Technical BULLETIN

SAFETY RECALL

ALL 2008 ~ 2015 WR250R AND 2008 ~ 2011 WR250X MODELS FACTORY MODIFICATION CAMPAIGN – Stator Coil Failure

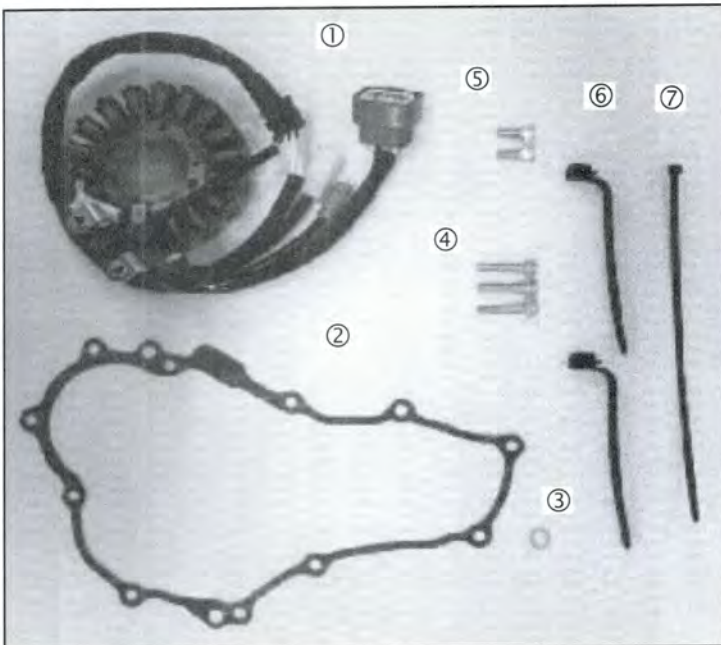
To correct this defect, Yamaha is initiating a Factory Modification Campaign. Affected units must have the stator coil replaced with a new one with sufficient heat resistance.

Parts Identification

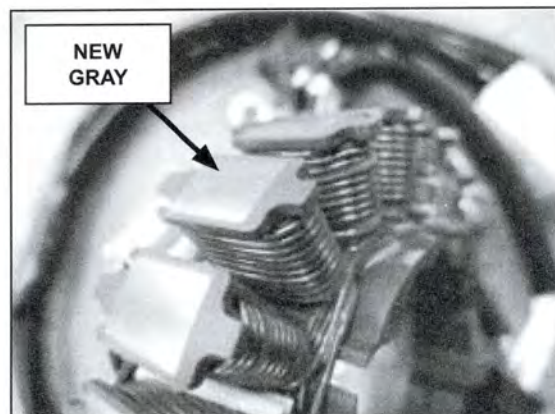
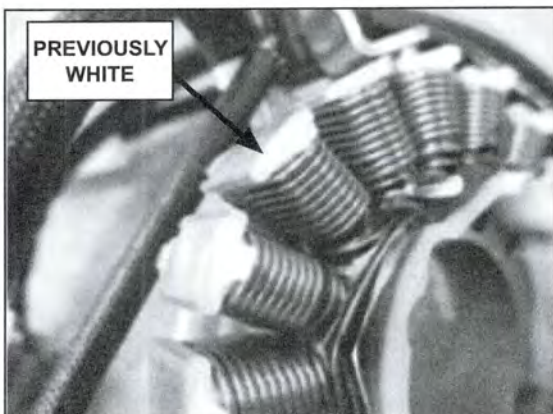
A new style stator can be identified by the gray-colored core. The original stator had a white colored core. See *Parts Information* section below for details.

The color of the new stator is changed as shown.
